**CULTURAL RESOURCES OFFICE
PRESERVATION BOARD
REGULAR MEETING
MONDAY AUGUST 27, 2012 - 4:00 P.M.
1520 MARKET ST. #2000
www.stlouis-mo.gov/cultural-resources**

DATE: August 27, 2012
FROM: Jan Cameron, Preservation Administrator, Cultural Resources Office
SUBJECT: Preliminary review to construct a 2 ½-story residential building
ADDRESS: 1722 Carroll Street
JURISDICTION: Lafayette Square Historic District — Ward 6

DATE: August 27, 2012
FROM: Betsy Bradley, Director, Cultural Resources Office
SUBJECT: Appeal of Director's denial of demolition permit
ADDRESS: 3318 Wisconsin
JURISDICTION: Benton Park Local Historic District, Benton Park National Register District,
Preservation Review District — Ward 9

DATE: August 27, 2012
FROM: Bob Bettis, Cultural Resources Office
SUBJECT: Appeal of Director's denial to keep retaining wall
ADDRESS: 913 Allen Avenue
JURISDICTION: Soulard Certified Local Historic District — Ward 7

SITE PLAN, SHOWING SETBACK
AND REAR GARAGE

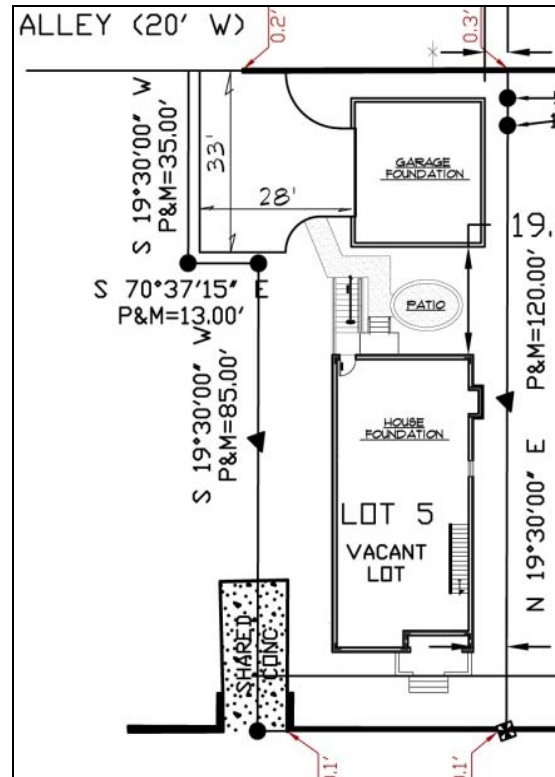
Complies. The building will be sited in line with the existing building at 1710. As there were no extant buildings on the property, this setback duplicates the setback of the north side of Carroll.

Complies. No grades will be substantially altered and the existing retaining wall will be maintained.

Complies. Proposed garage will be located directly behind the house.

Complies. Curb cut will be located at the alley.

BLOCKFACE OPPOSITE THE SITE ON CARROLL — NOTE CHANGE IN SCALE

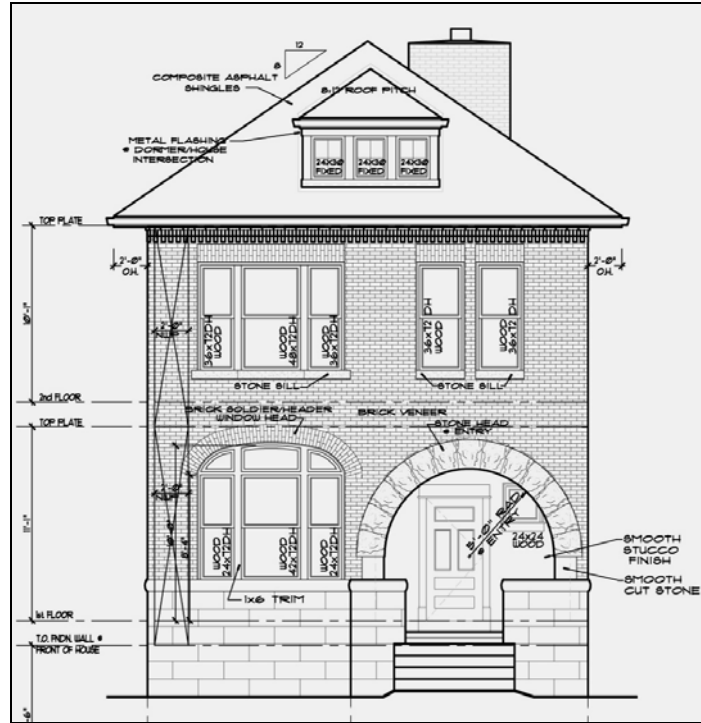
Complies. The proposed building shares the massing and scale of the previously-approved design at 1710 Carroll and will have the same façade width and cornice height. It will have a hipped roof, however, thereby increasing the perception of its scale. The situation of a 2½-story building adjacent to a 2-story is not uncommon within the district.

WEST ELEVATION

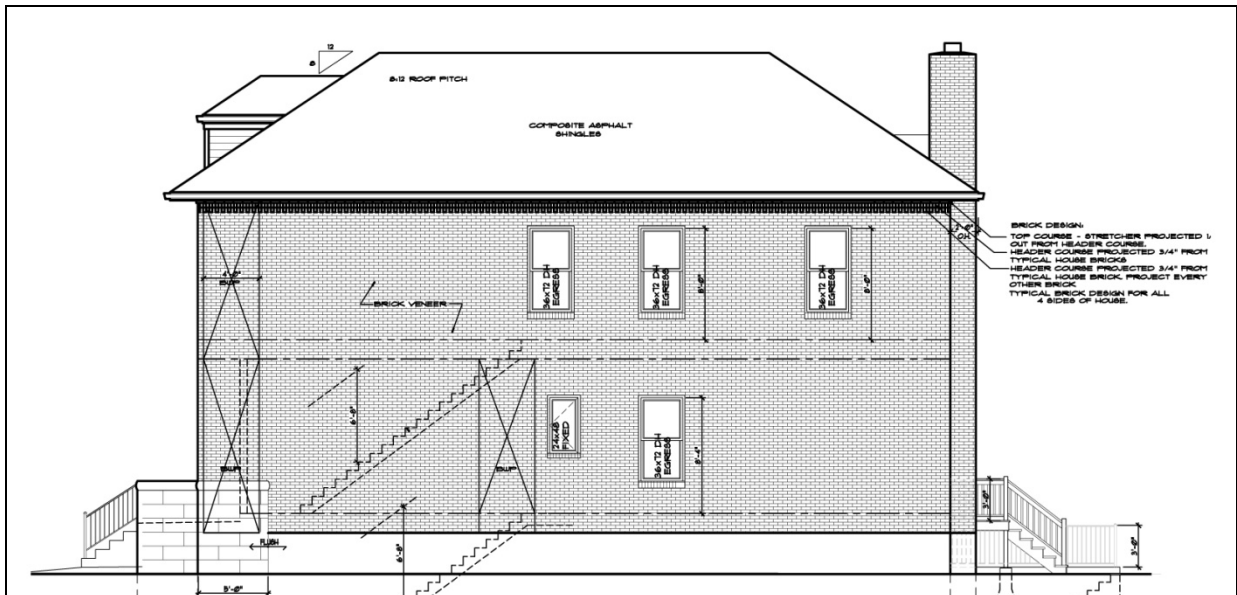
Aside from the question of the use of a Historic Model Example, the project would comply with these requirements.

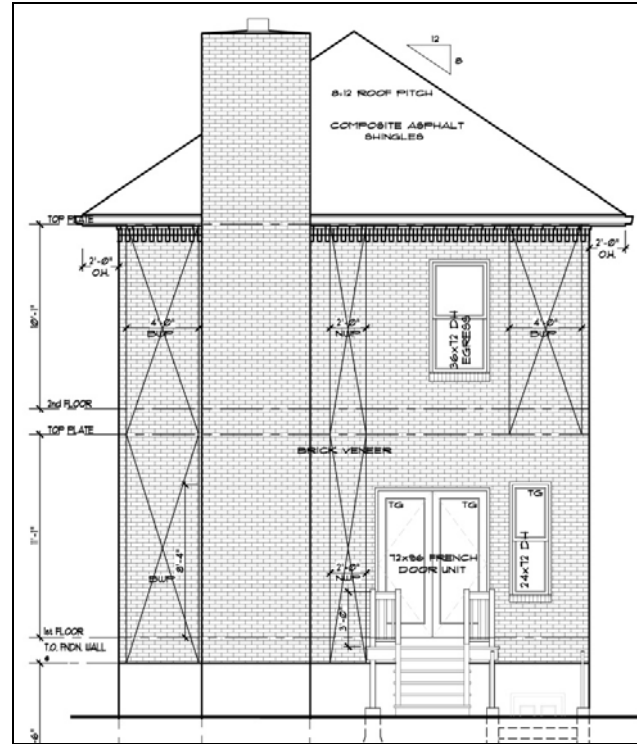
Does not comply. There would be no differentiation between the brick of the front façade and the rest of the building.

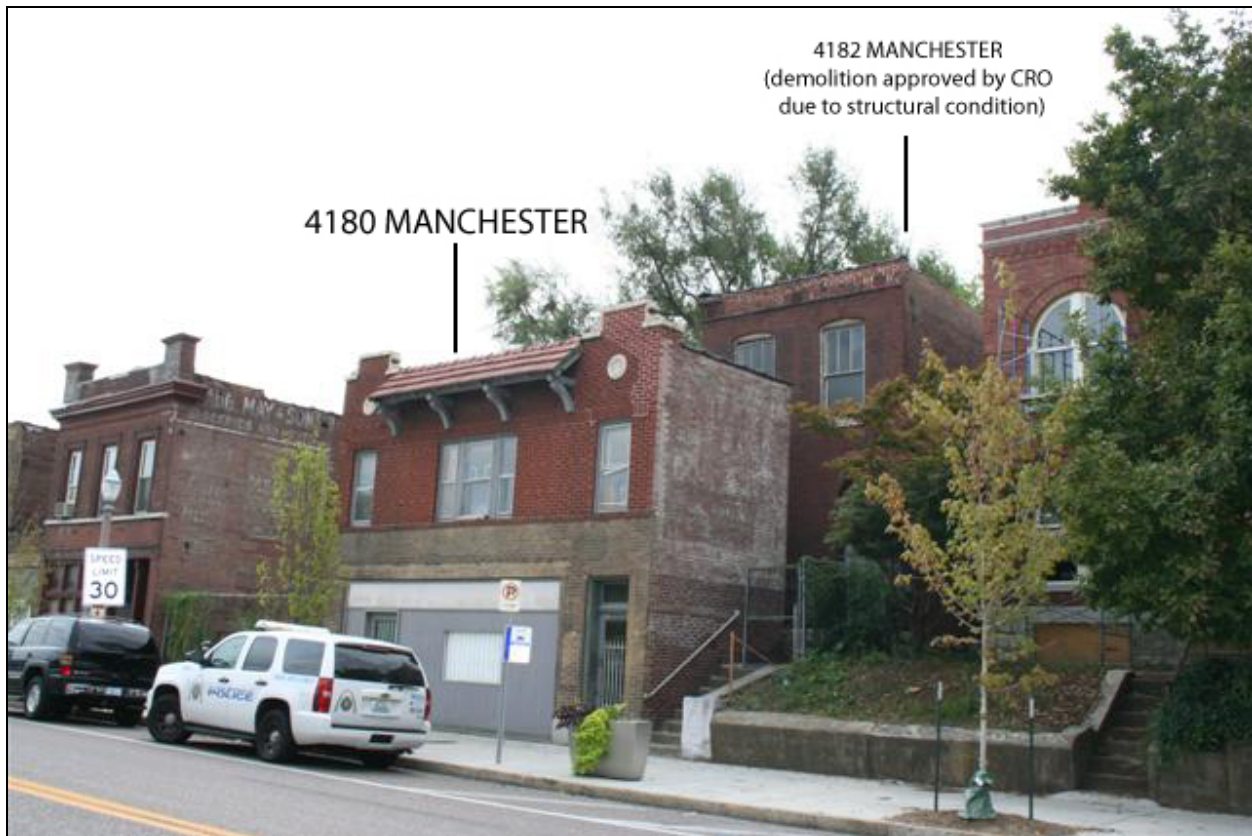
4180 Manchester is a relatively small L-shaped building that has a storefront on Manchester. As noted above, the block and area are being upgraded as buildings are put back into use and it is likely that storefronts of various sizes will be in demand.
